SOUTH HIGH SCHOOL SECOND ADDITION
TO WICHITA, SEDGWICK COUNTY, KANSAS

RE: SUB 2003-90 - One-Step Final Plat of South High School Second Addition

CASE NUMBER: SUB 2003-90 -- SOUTH HIGH SCHOOL SECOND ADDITION

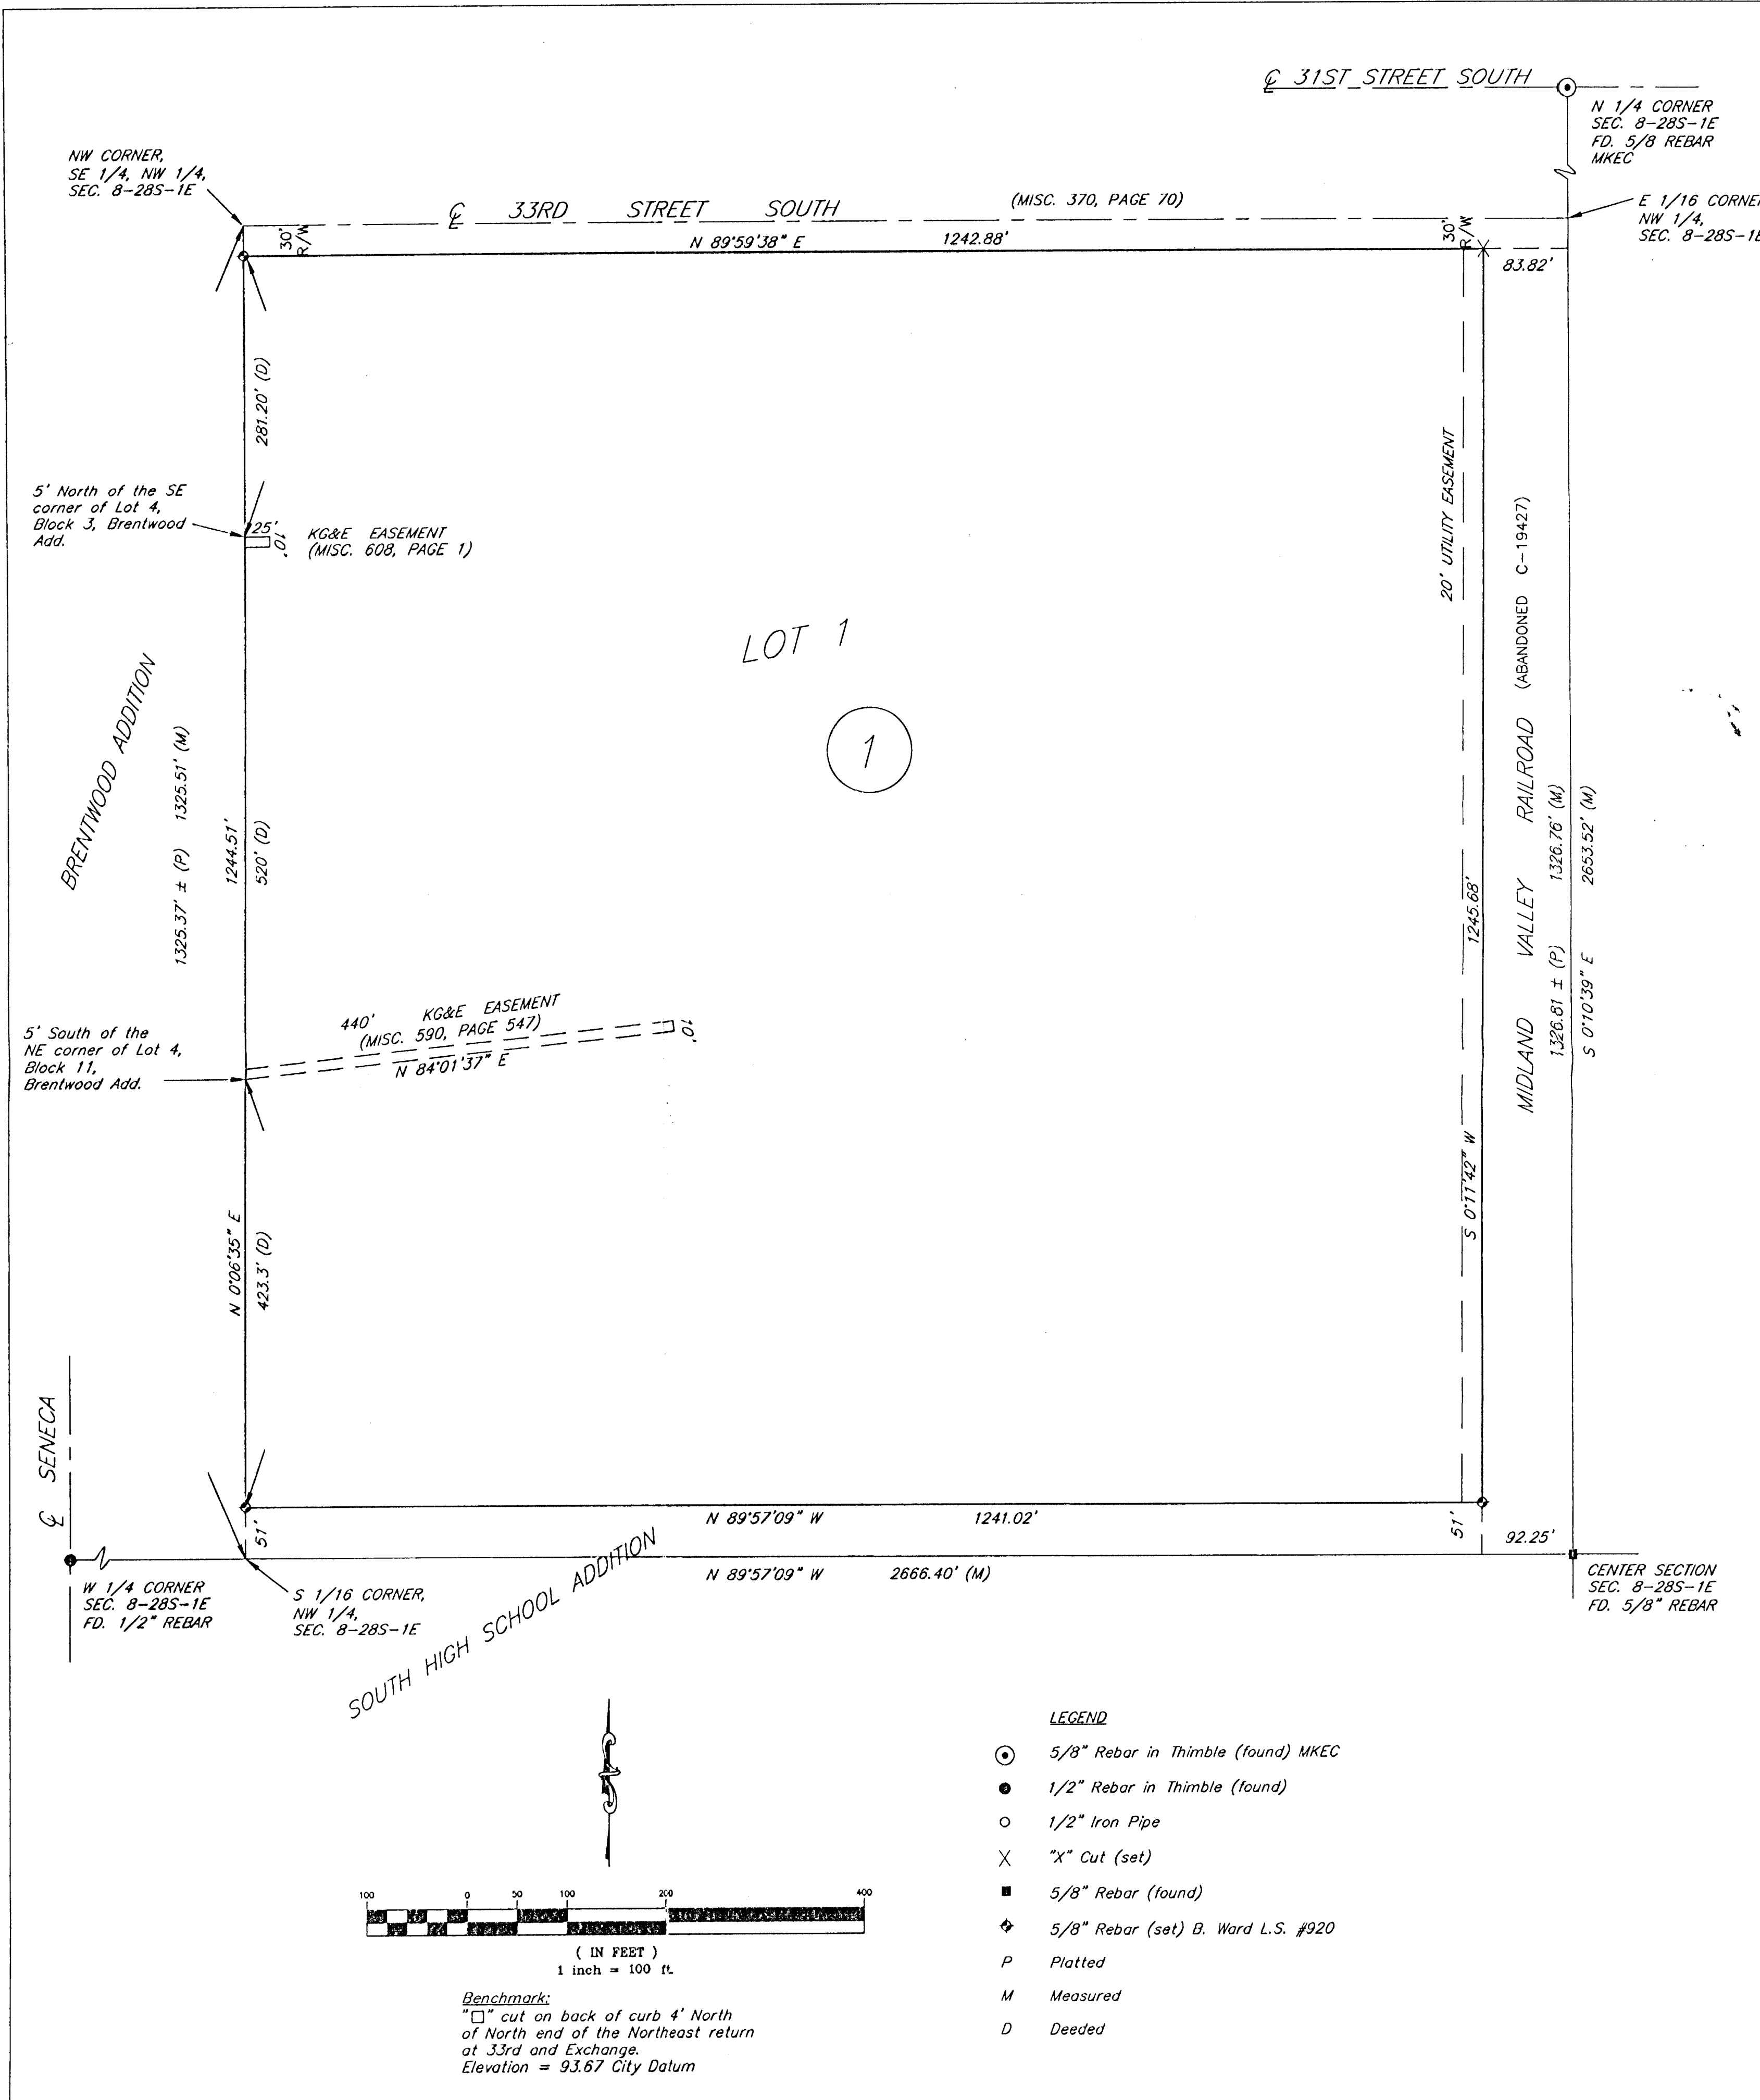
- A. Municipal services are available to serve the site. City Engineering needs to comment on the need for guarantees or easements. City Water and Sewer Department has requested a 20-ft easement along the east line of the plat for future water line improvements.

- C. City Engineering needs to comment on the status of the applicant's drainage plan.
- D. County Surveying advises that the bench mark needs an elevation.

- E. County Surveying requests a dimension of the width of the south end of railroad right-of-way.
- F. The SW, NW and NE corners of the SE 1/4 of the NW 1/4 need labels.

- G. County Surveying advises that the KG&E easements must be shown with sufficient ties to locate them definitely with respect to the subdivision.
- H. The centerline of 33rd St. South should be denoted.

- I. The dimension denoted for the west property line needs to be corrected.
- J. The 40-ft utility easement along the south line of the plat is located in the adjoining plat and may be deleted from the final plat tracing.

- M. The MAPC signature block needs to be revised to reference "John L. Schlegel, Secretary".
- N. The Applicant is reminded that a platting binder is required with the final plat. Approval of this plat will be subject to submittal of this binder and any relevant conditions found by such a review.

- O. The plat title should reference "Wichita, Sedgwick County, Kansas".
- P. *The platlor's text shall include language that a drainage plan has been developed for the plat and that all drainage easements, rights-of-way, or reserves shall remain at established grades or as modified with the approval of the applicable City or County Engineer, and unobstructed to allow for the conveyance of stormwater.*
